**RE DAs 202138229, 202138359, 202138251 – CIT Woden Bus Interchange**

Thank you for the opportunity to comment on these proposals. While the Woden Valley Community Council (WVCC) welcomes an upgraded bus interchange, we want it to be safe, integrated into the town centre and have the capacity to meet the **future demand** for public transport services in Canberra's south – **with Woden a destination not just a transit hub**, see **Attachment A**.

Figure 7-1: Risks and mitigation strategies, Pre-light rail construction

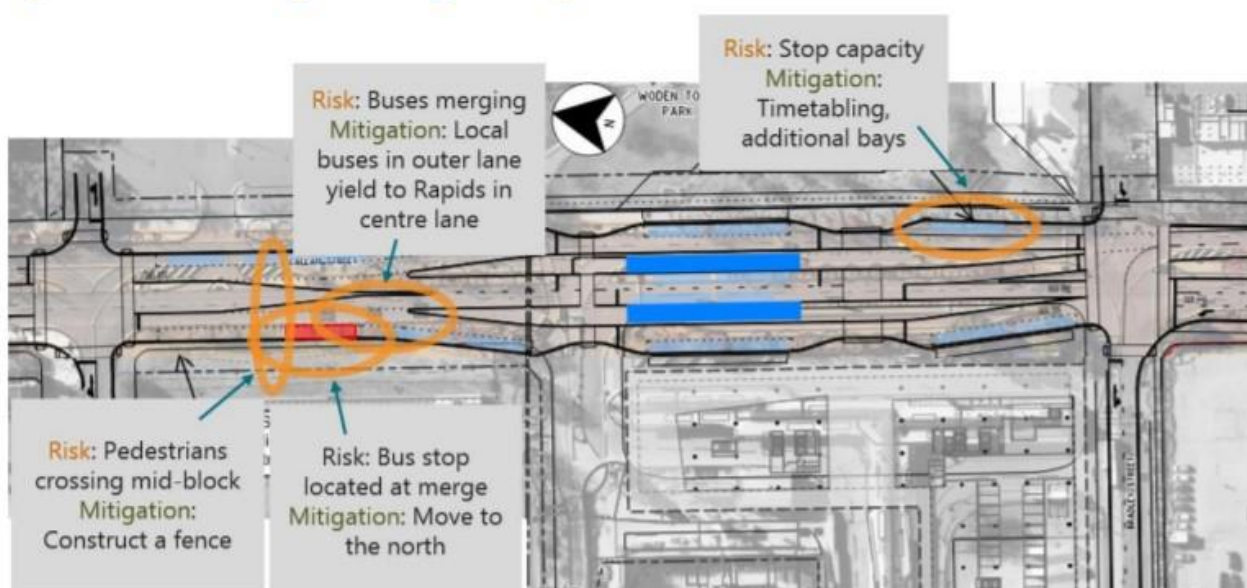
The VLC September 2020 Infrastructure Requirements report concludes that the design brings up numerous safety concerns and suggests that a qualified engineer undertakes an Operational Risk Assessment to determine whether the facility can operate safely.

What work has the ACT Government undertaken to understand the risks and assure the community that the interchange is safe?

Figure 6-5: Proposed Callam Street interchange at horizon 5, (bus volumes during AM peak)

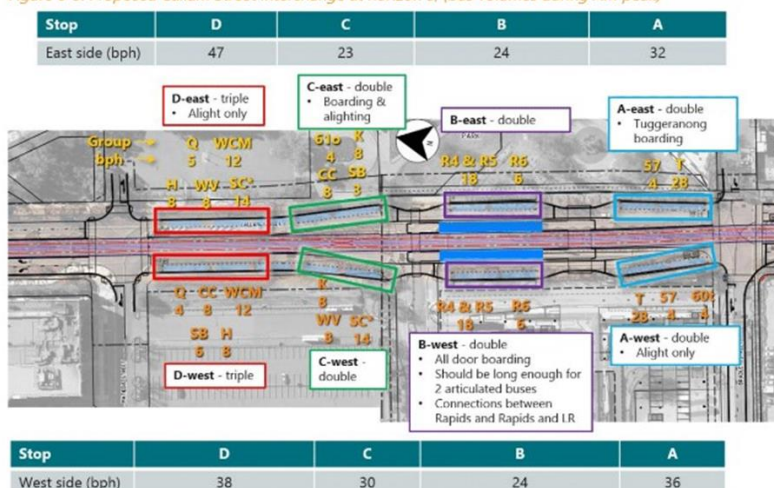
Given the bus bays are around 38 metres long (Civic's are around 60m) and may have to operate head of queue services (first in first out), buses are likely to have to go to the bus layovers between runs. This will create additional trips through the interchange for buses to get to and from the bus layovers and get to the boarding platforms.

It is a major concern that the interchange is being built without an understanding of when capacity will be reached and how we are future proofing the interchange to ensure its ongoing efficient operation. We should consider keeping the southern loop to future proof public transport services and build the CIT on the carpark between the Hellenic Club and Grand Central.

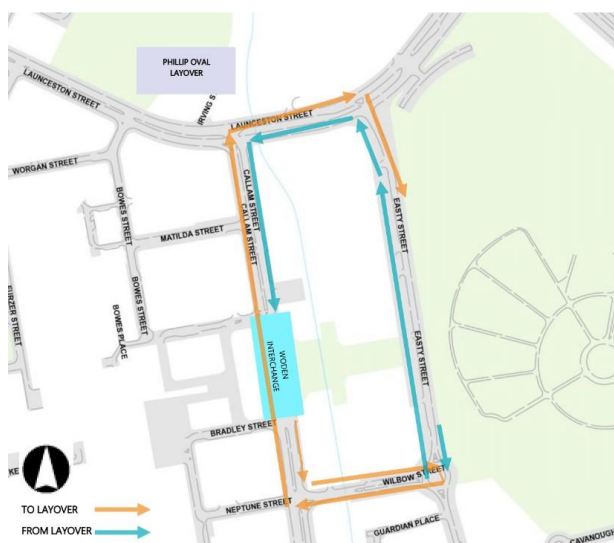
The Woden interchange is unique, it has separate platforms for trams and buses and all transfers require people to cross bus movements.

We should look at a design that uses the same platforms for trams and buses for safety.
